HMT500(ED260313A) A5-R3 / TOP / ACTUAL PCB SILKSCREEN

Reference height 0.80 / 0.60 mm, stroke 0.10 mm | DOTECH full logo width 11.5 mm (TOP)

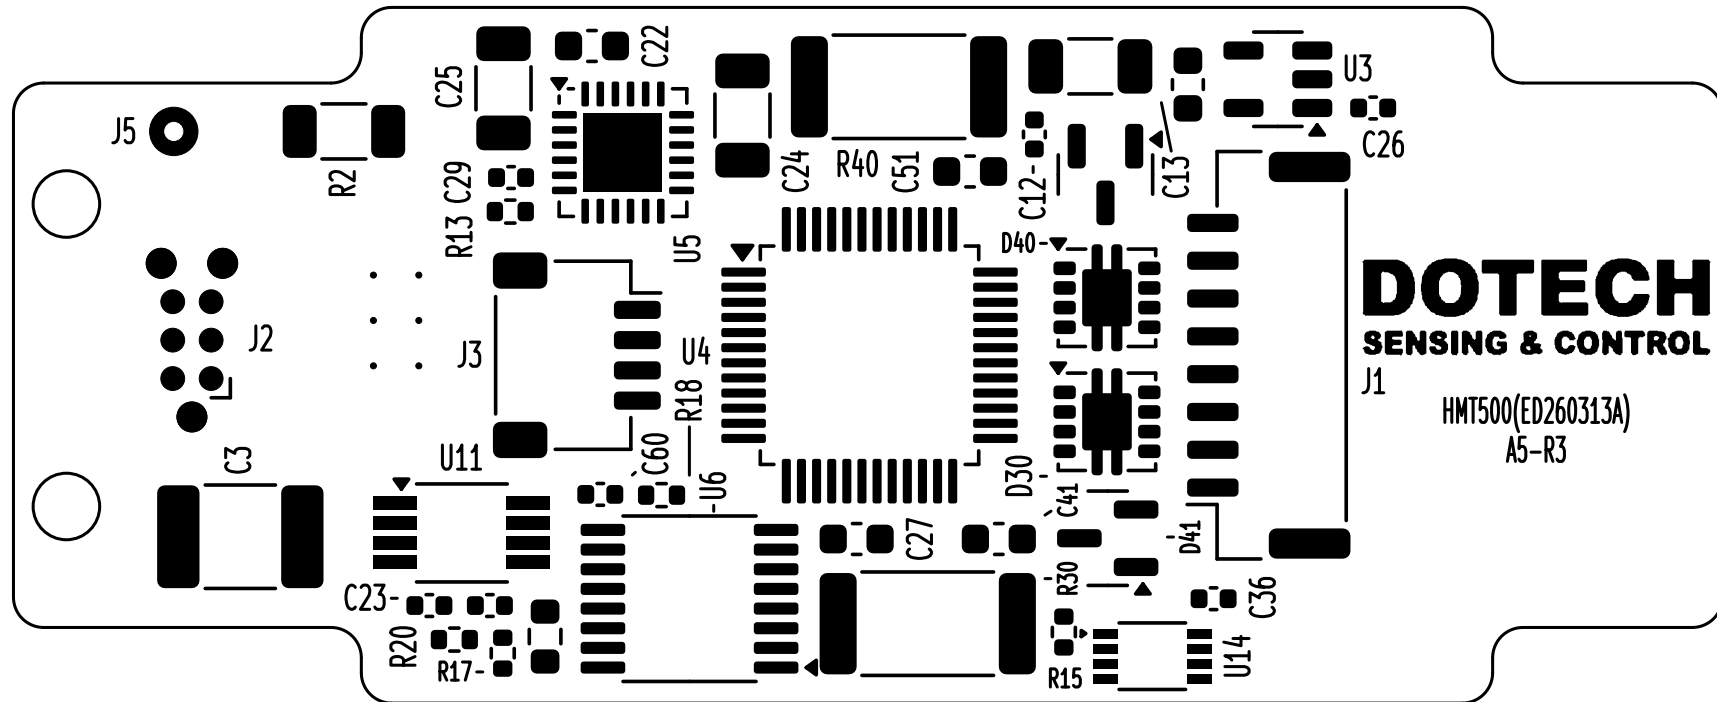
92/110 refs printed; 18 omitted; 22 refs at 0.60 mm require fabrication legibility confirmation.
